SAN ANSELMO FLOOD RISK REDUCTION PROJECT

Final Environmental Impact Report
Volume 2 - Response to Comments
State Clearinghouse No. 2017042041

Prepared for
Marin County Flood Control and Water
Conservation District

Figure 4.5-5
Critical Habitat in the Vicinity of the Project Sites

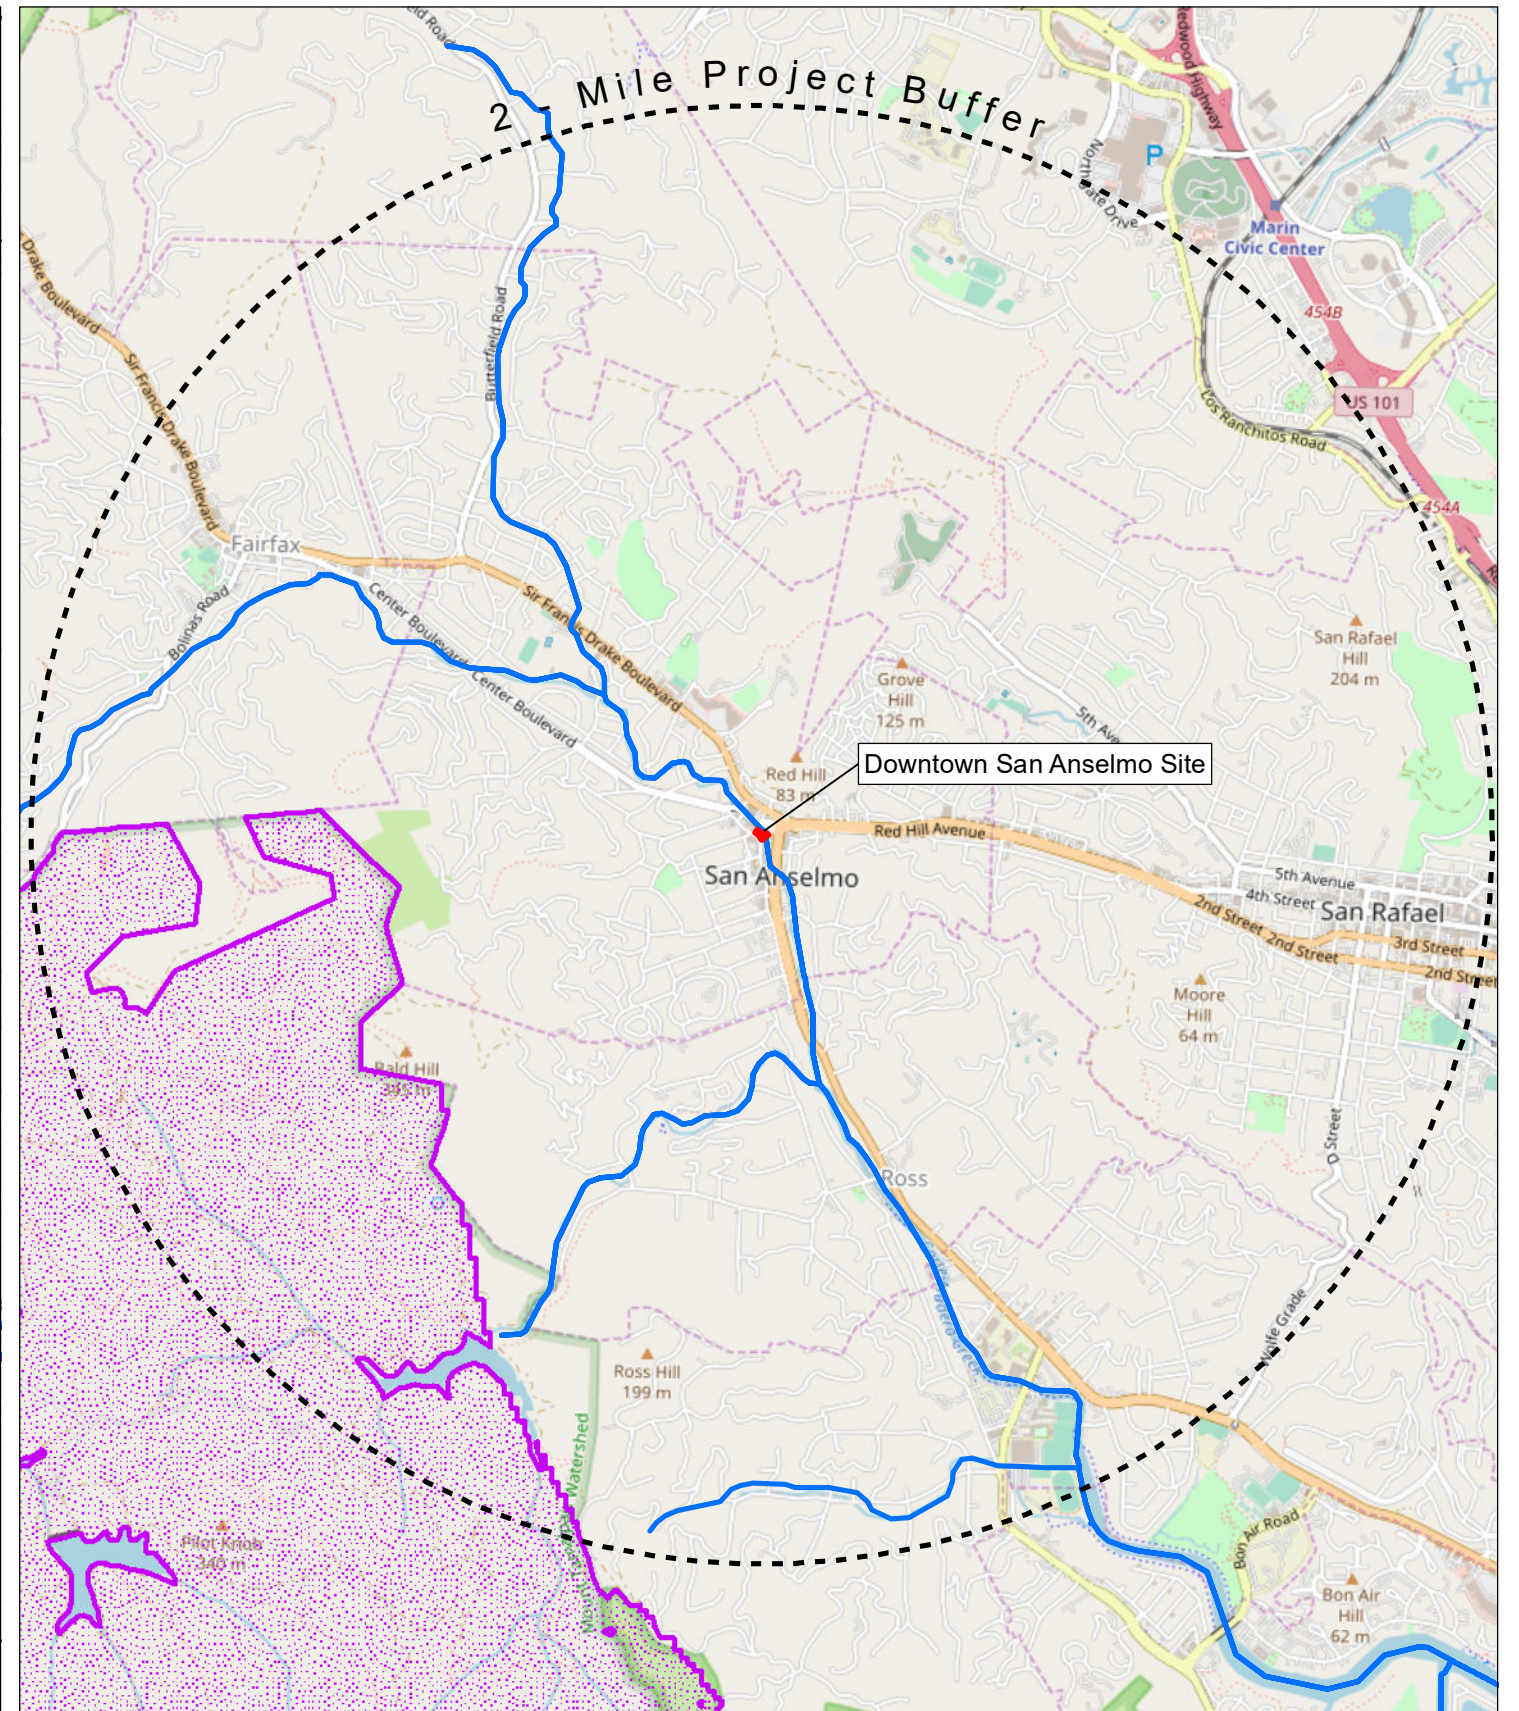
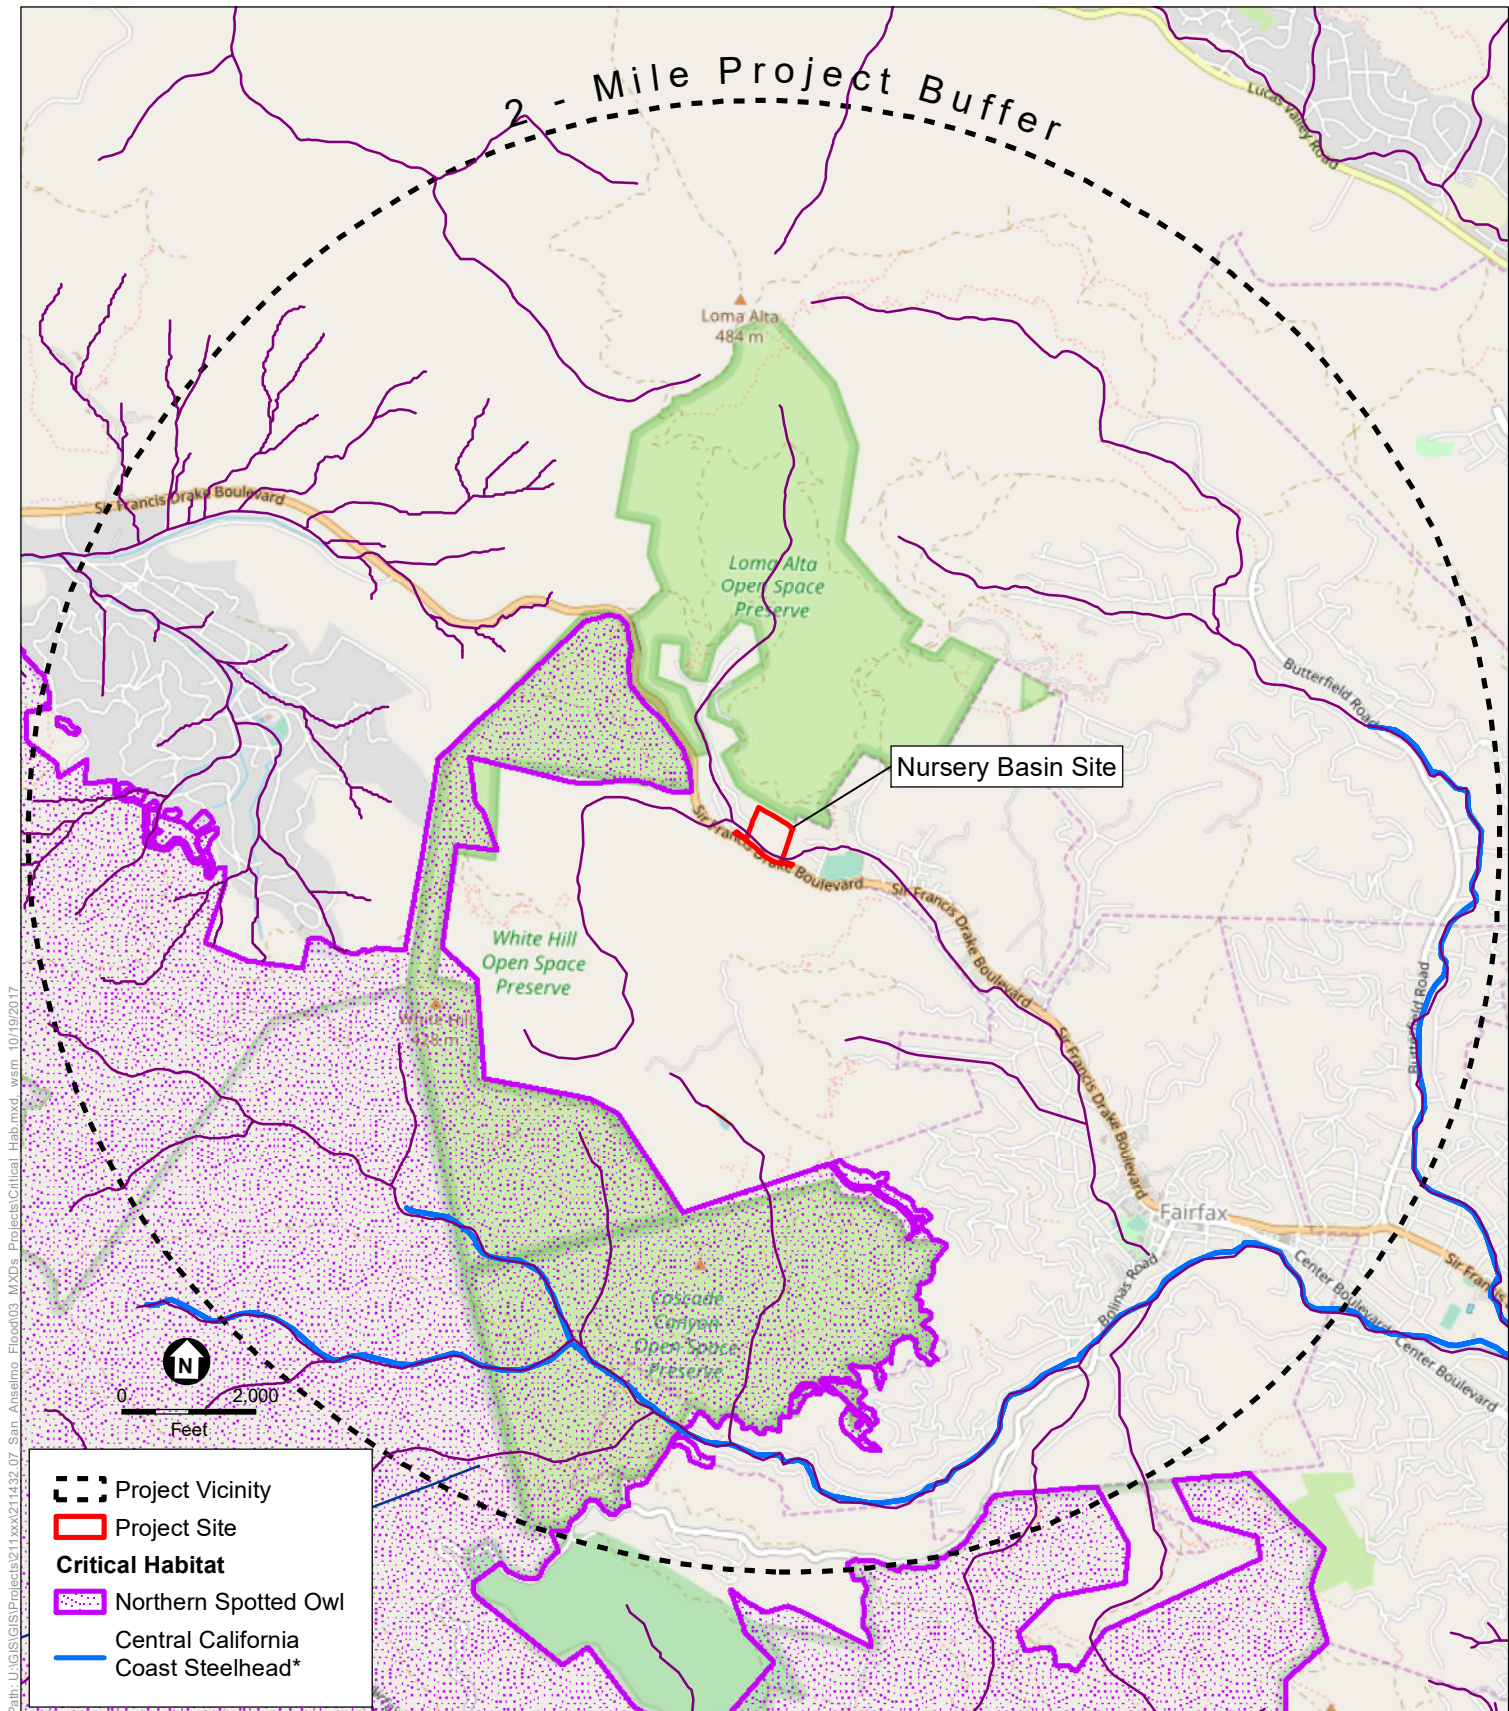
The mouth of Tamalpais Creek is not accurately depicted on Figure 4.5-5. Tamalpais Creek enters a culvert at Kent Avenue and joins Corte Madera Creek just downstream of the concrete channel. The relict mouth located near College of Marin Parking Lot 13 is no longer connected to Tamalpais Creek.

Draft EIR Figure 4.5-5 has been revised in response to this comment. The data source was the U.S. Fish and Wildlife Service, however, not original work done for this comment. The referenced creek is far downstream from the project area in downtown San Anselmo.

In response to Comment B1-6, the portrayal of Tamalpais Creek on Draft EIR Figure 4.5-5 (page 4.5-21) has been revised, as shown below.
